# INNER WEST

## DEVELOPMENT ASSESSMENT REPORT

<b>Application No.</b>	DA/2020/1017
<b>Address</b>	317 - 335 Liverpool Road ASHFIELD NSW 2131
<b>Proposal</b>	Demolition of the existing structures on site and construction of an eight storey mixed-use development comprising ground floor retail tenancies, 28 residential apartments, two level basement parking and a communal roof top garden.
<b>Date of Lodgement</b>	27 November 2020
<b>Applicant</b>	Markham Property Development Pty Ltd
<b>Owner</b>	Frank and Sunny Pty Ltd GY Investments Australia Pty Ltd Ganghui Pty Ltd
<b>Number of Submissions</b>	Initial: (2)
<b>Value of works</b>	\$10,877,634.00
<b>Reason for determination at Planning Panel</b>	Development to which SEPP 65 applies and Development involves the demolition of a heritage item
<b>Main Issues</b>	Clause 4.6 variations to height & FSR, variations to ADG setback requirements and proposed demolition of a heritage item
<b>Recommendation</b>	Approval with Conditions

Figure 3 – Section detailing elements of the proposed height variation.

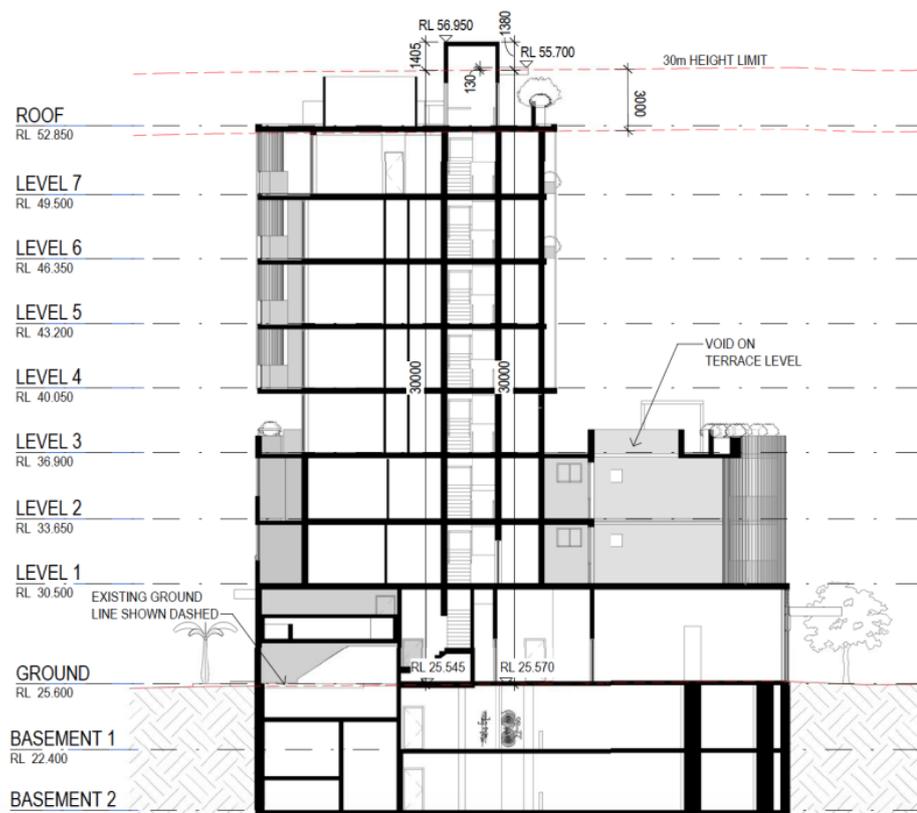
- *The proposed development is considered to be compatible with the streetscape along Liverpool Road and Markham Place;*
- *The proposed building has a maximum height of 27.25m (or RL 52.85) when measured to the upper level roof form and generally meets the height control under Clause 4.3A. A 1.405m non-compliance is introduced above to and facilitate lift service to the roof garden. The lift overrun provides access to rooftop communal open space, contributing to the residential amenity of the development. This is best illustrated through figure 3 below.*

- *The lift overrun is located centrally to the built form and does not contribute to the scale of the building; and will not be visually dominant.*
- *The additional height above Clause 4.3A does not result in any additional amenity impacts to the adjoining properties with no additional overshadowing generated by the lift overrun which is being located centrally to the roof form;*

- *The proposed communal rooftop garden does not contain any floor space and is not reasonably capable of modification to include floor space area at a later stage.*
- *The variation will not result in overlooking that would adversely impact the visual privacy of adjoining properties. The communal rooftop garden is located within the height limit under Clause 4.3A and landscaping has been provided to maximise privacy; and*
- *The proposal provides access to functional open space at the roof terrace which provides additional solar access compared to the other communal space on the southern edge of the building. The proposed communal rooftop garden seeks to encourage social interaction and provide a space for relaxation for residents;*

The applicant’s written rationale adequately demonstrates that compliance with the development standard is unnecessary in the circumstances of the case, and that there are sufficient environmental planning grounds to justify contravening the development standard.

Figure 3 – 317 Liverpool Road frontage to Liverpool Road – Heritage item

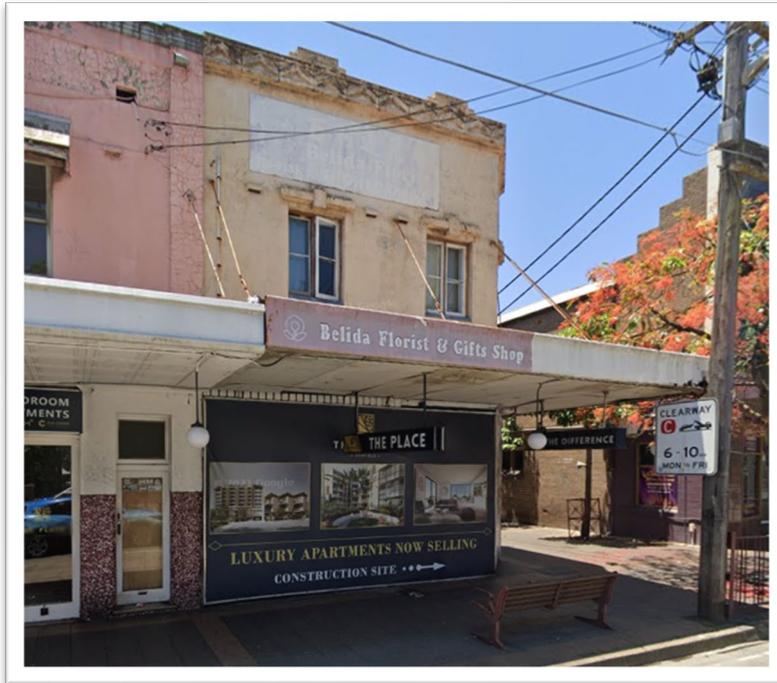
The current proposal and subsequent re-request for the demolition of the existing heritage item has been reviewed by Council’s heritage advisor, who has outlined an objection to the demolition of the heritage building. Council heritage advisor has maintained this objection to demolition following the submission of amended plans and further review and analysis of the previously provided heritage fabric analysis and photographic record (required under conditions of consent for DA 10.2016.89).

As part of the assessment process Council planners have reviewed the above heritage advice and considered it against the previous site history. In this instance the original surviving fabric and elements which contribute to the streetscape is located above the existing awning on level 1, with ground floor elements altered and removed to a point of not retaining significance, this is best illustrated through figures 3 and 4 below. The retention and protection of the heritage façade would require a significant re-design of each level of the proposal (including basement). This is unreasonable as Council has previously stated that this heritage item is not worthy of retention and provided consent for the structure’s demolition (still operational).

In this instance the retention of the heritage items façade is not readily feasible and as such demolition is recommended for support. The retention of the building's façade provides reduced opportunities for the introduction of new retail spaces and limits opportunities for activation of adjacent lane known as Markham Ave. The current proposal provides a significant improvement to activation along Markham Avenue, through the introduction of significant new glazing and retail spaces. Any proposal which seeks to retain the heritage façade would either

provide a significantly reduced extent of activation or involve a substantial removal of heritage fabric to accommodate the same extent of glazing. The proposed façade retention is not considered to be in the public interest and is not recommended for retention.

Figure 2 Level 7 – Reference Plan  
Source: Nettletontribe

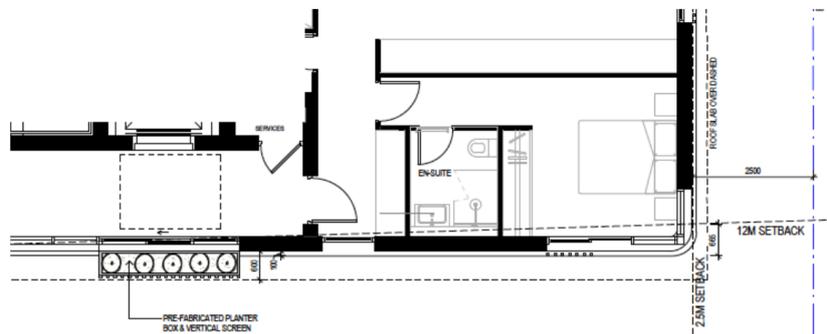
The proposal includes a 12 metre street frontage height on Liverpool Road and complies with the control. However, the proposal does not afford a strict 12m setback above the wall height frontage to Liverpool Road for the full length. A small portion of the building intrudes within the 12 metre setback to Liverpool Road (up to approximately 0.665 metres at the eastern boundary) due to the site's existing shape (Refer to figure below).

The proposed FSR presents a variation of 5.54% to the 12m setback control fronting Liverpool Road.
